Our Ref: 023-1944 WEPA - PAN-026789 NRW Response REV00

WEPA UK Ltd – PAN-026789 (EPR/EP3738NG/V006) Response

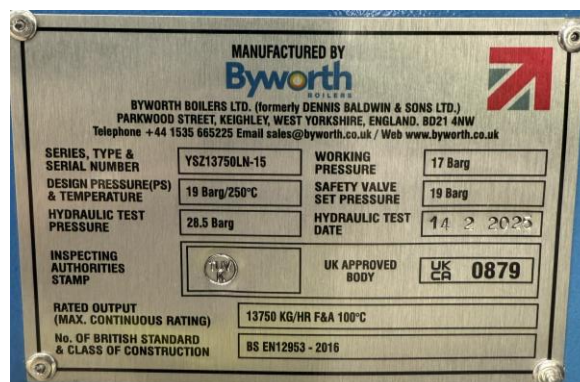
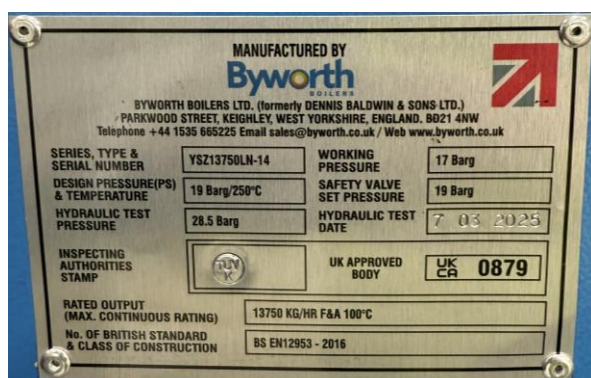
NRW: Provide us with more information on the Form Part C3 appendix 8 question 1 –the serial numbers for both of the Medium Combustion Plants. There was only one serial number provided in the application form.

The requested modification has been made. The revised form C3 is attached. The specific MCPD equipment plates are provided below.
